**General Bid Bulletin No. 18**  
08 July 2021

**RESPONSES TO CLARIFICATION REQUESTS**

**IFB No. 21-036-5;** South Commuter Railway Project for Package Number CP S-03a: Building and Civil Engineering Works for approximately 7.9 kms of at Grade and Viaduct Railway Track Structure including Elevated Station at Buendia and at Grade Stations at EDSA and Senate

General Bid Bulletin No. 18  
CP S03A and CP S03C Responses to Clarification Requests (Batch 7)

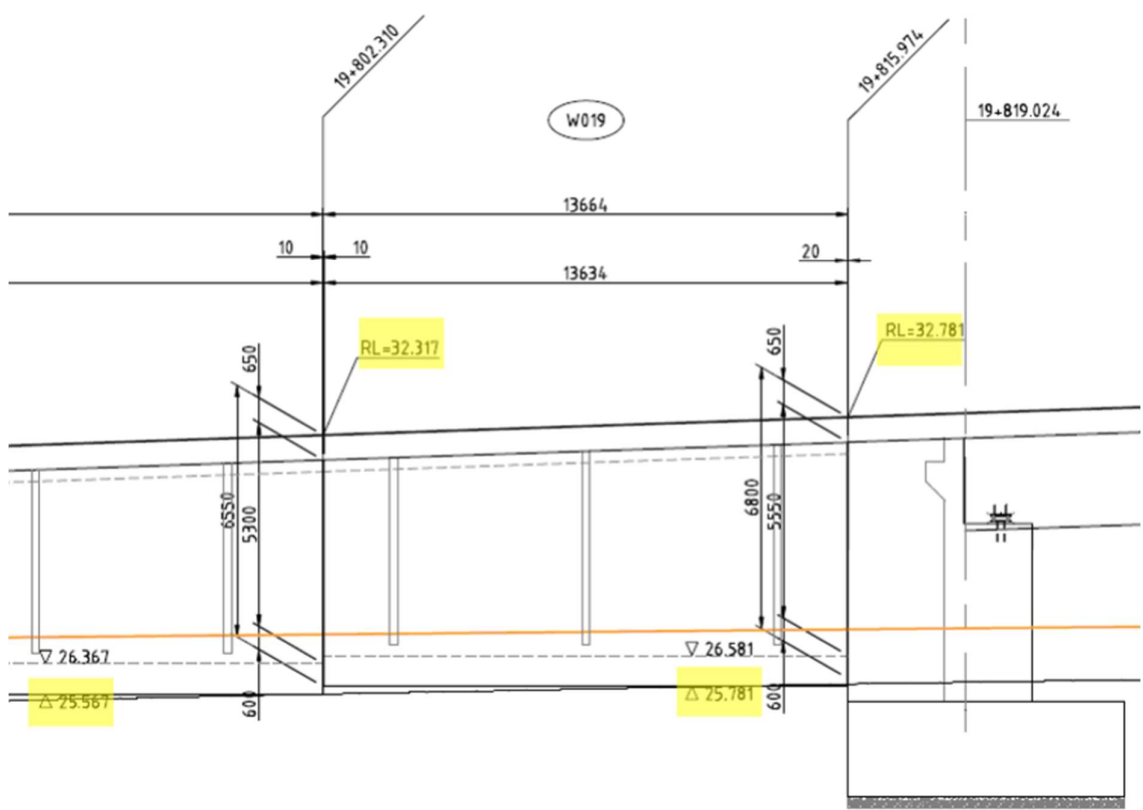
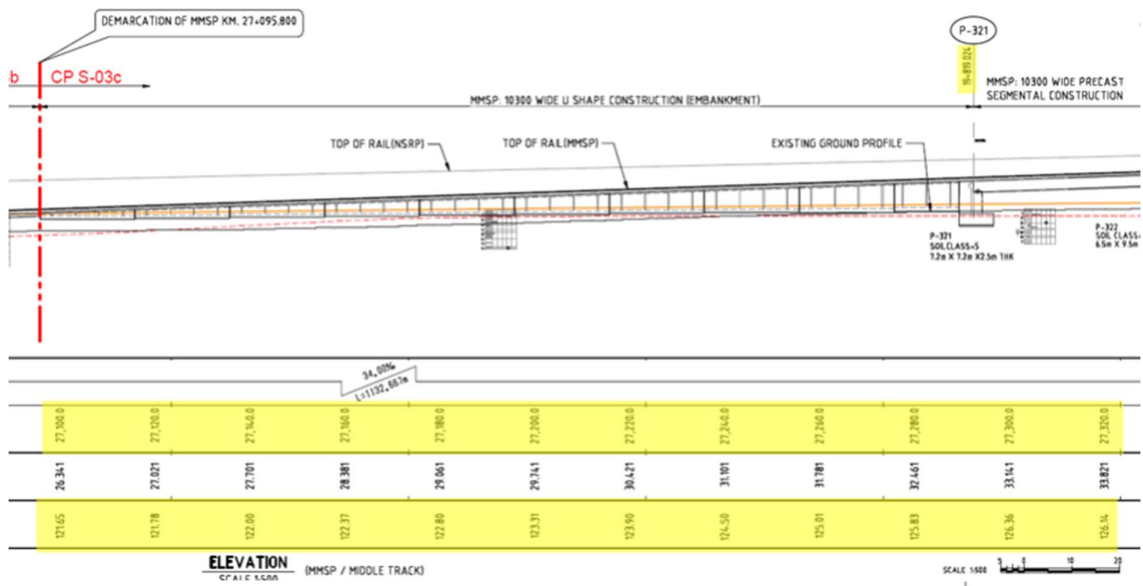
124	S-03A		NSRP-DWG-ATG-ST-3105, 3211, 3212, 3300			Please refer to drawing to be revised NSRPDWG-ATG-ST-3105,3104,3106, 3211 & 3212 rev21.3 and issued with Bid Addendum 2.	The cross drains and fume tube locations in the at-grade structure are not matching compared to the general layout, drainage drawing and elevation. Which drawing will govern?	The drainage drawings shall govern. Please refer to drawing to be revised NSRP-DWG-ATG-ST-3105,3104 & 3106, rev21.3 and issued with Bid Addendum 3.
125	ALL		NSRP-DWG-VIA00-ST-1500 to 1561		Widening Deck Details	1). Deck widening locations and details, please refer to revised drawing NSRP-DWG-VIA00-ST-1571 Rev 21.3 which will be issued with Bid Addendum 3. 2). Refer to Bill 3 - concrete and rebar pay item 206 and 207 to include the deck widening which will be issued with Bid Addendum 3	Please provide the widening deck details which shall include but not be limited to location, reinforcement details, pay item in BOQ.	1). Deck widening locations and details, please refer to drawing NSRP-DWG-VIA00-ST-1571 2). Refer to Bill 3 - concrete and rebar pay item 206 and 207 to include the deck widening which will be issued with Bid Addendum 3.
